ADDENDUM NO. 1

PENROSE POINT STATE PARK ON-SITE SEWAGE SYSTEM UPGRADES SW-C2020

DATE: February 12, 2021

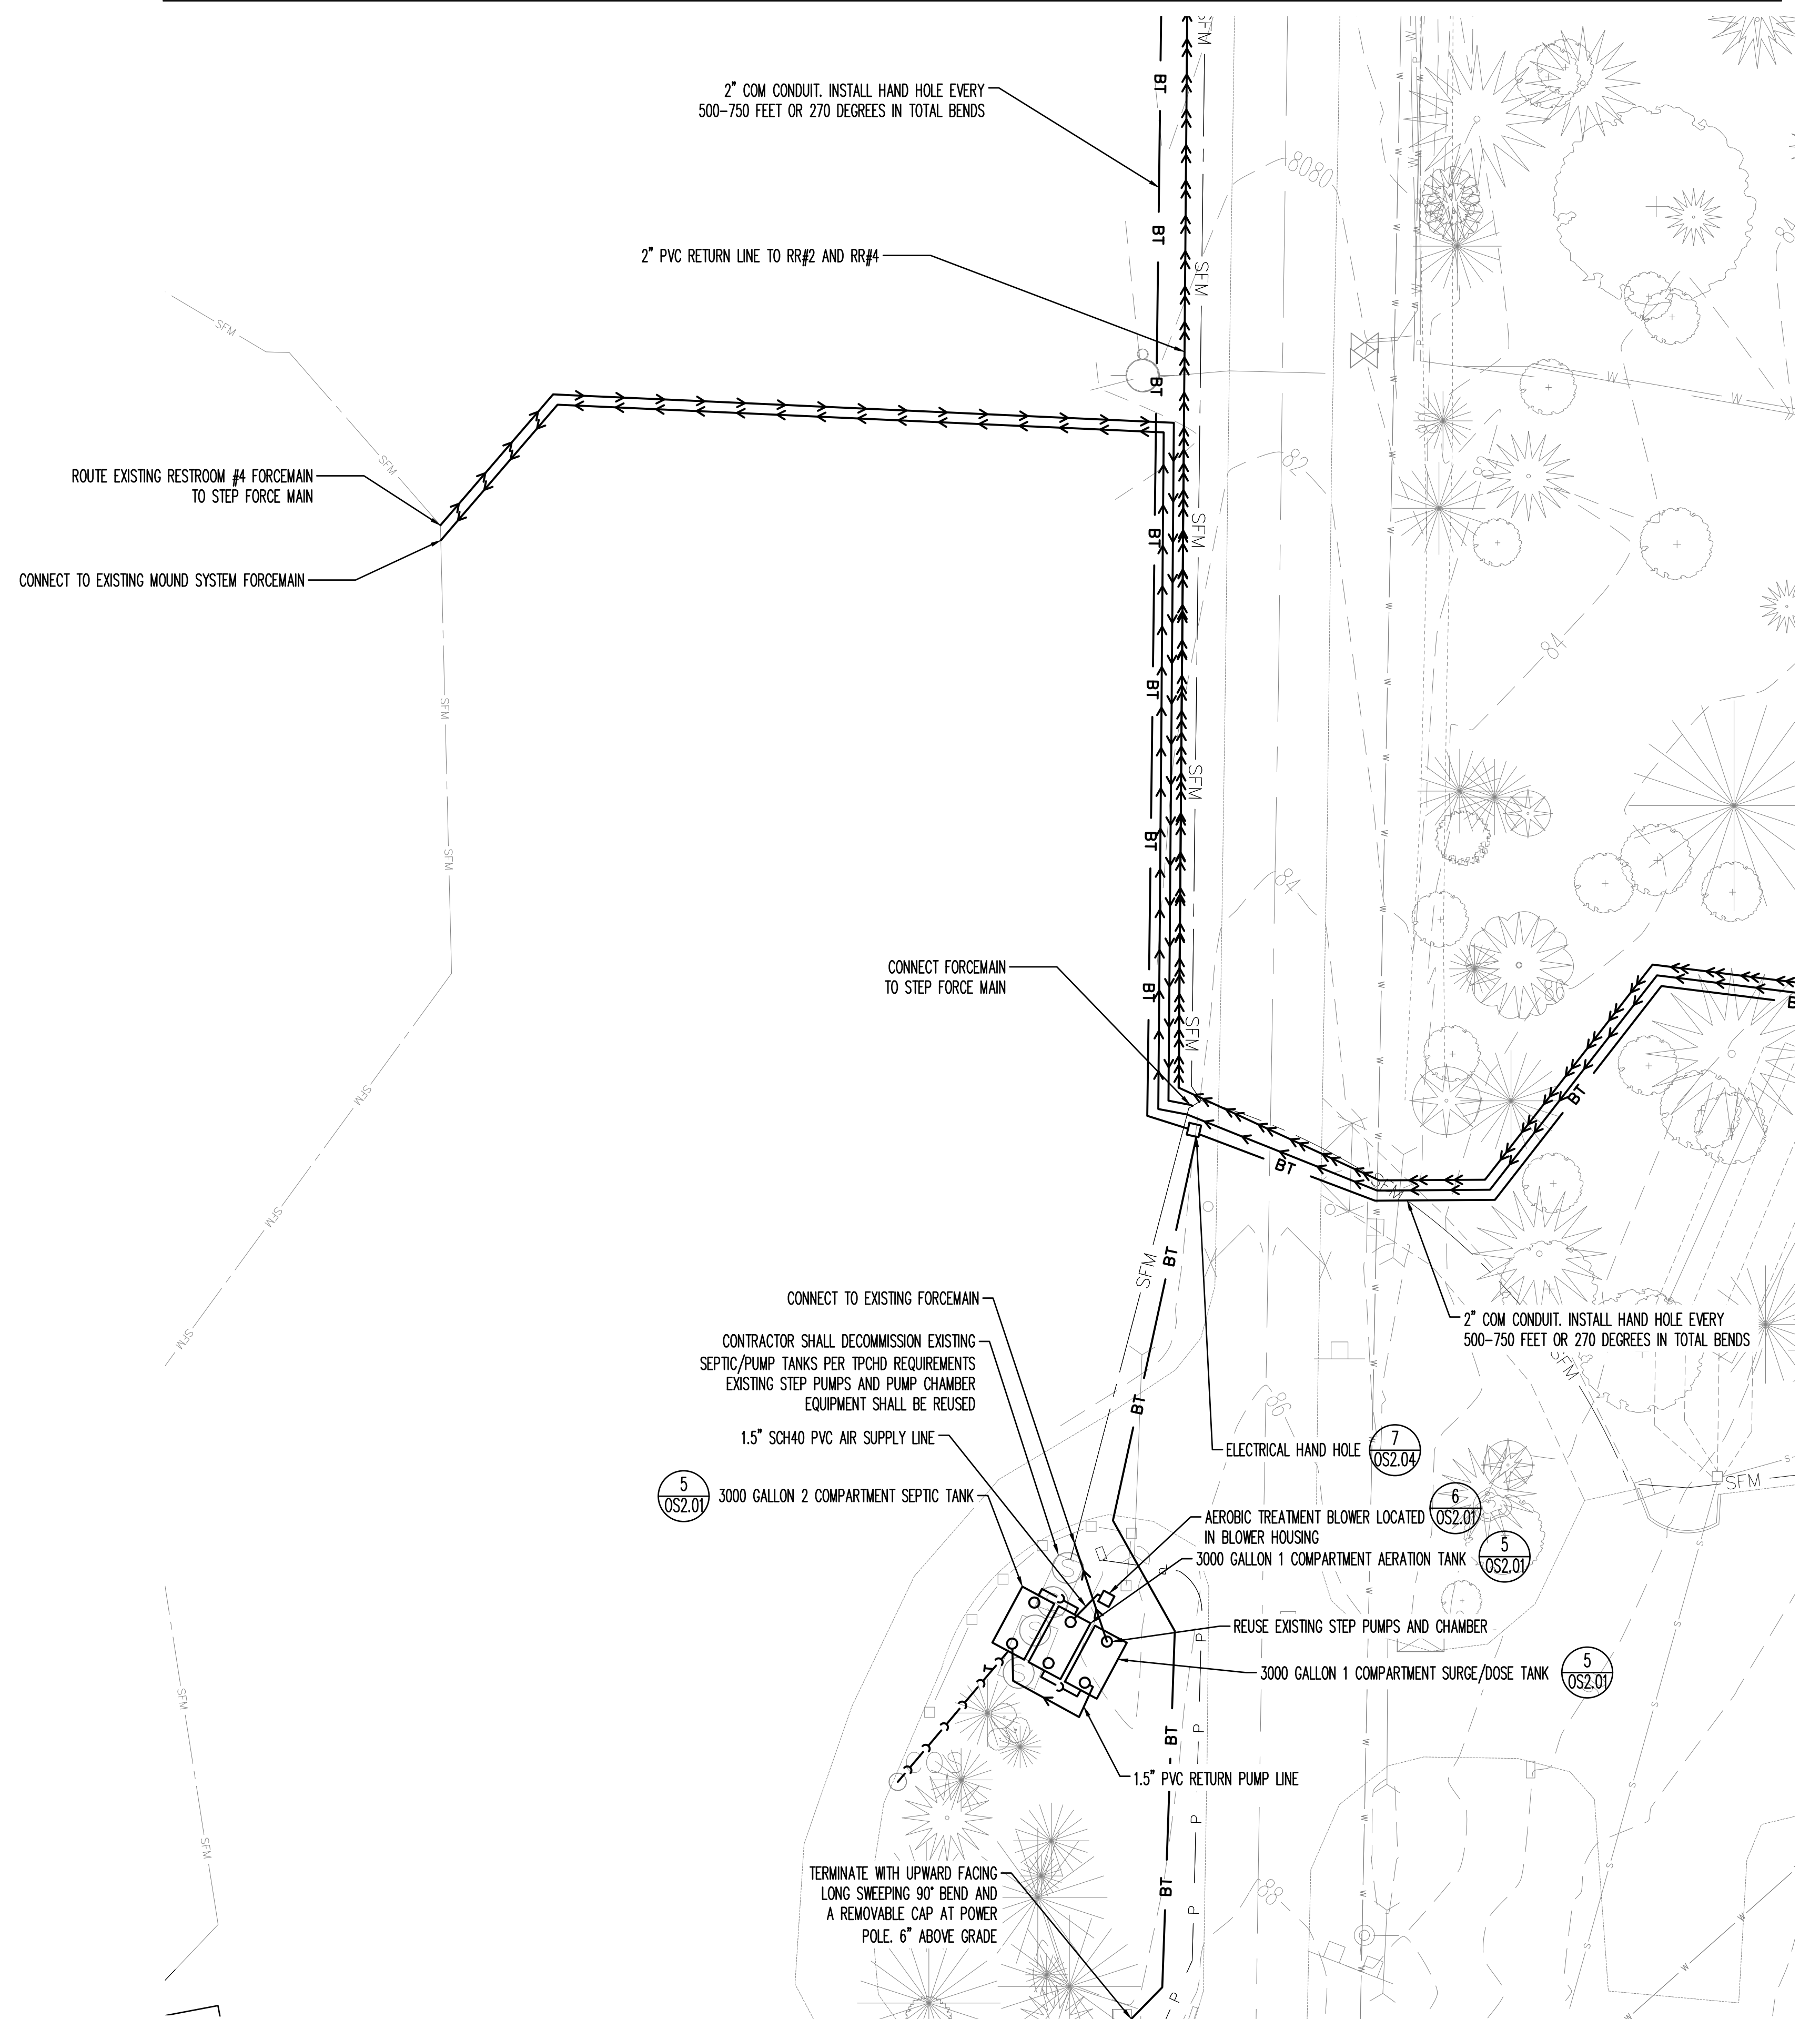
1. **OS2.03 Sheet 13 of 14 – KEYNOTES 16: ADD** Prefabricated Metal cover can be an arched cover or a center peaked structure. It shall be at least 6' tall at the center and if it is a center peaked structure it must be 4' tall at the edges, and have a minimum 1' eve. It can use the Center footing wall to support columns if necessary. The contractor is responsible for permitting of cover and shall include the cost in the Lump Sum cost for the Recirculating Gravel Filter.
2. **OS1.05 Sheet 8 of 14 – Replace with attached Sheet 8 of 14:** Note the changes in communication conduit routing and handhold.
3. **OS1.06 Sheet 9 of 14 – Communications Termination Note: Replace** Terminate COM. Conduit in Office with: Terminate Com. Conduit at back wall 6" above grade with an upward long sweeping 90 degree bend and removable cap.
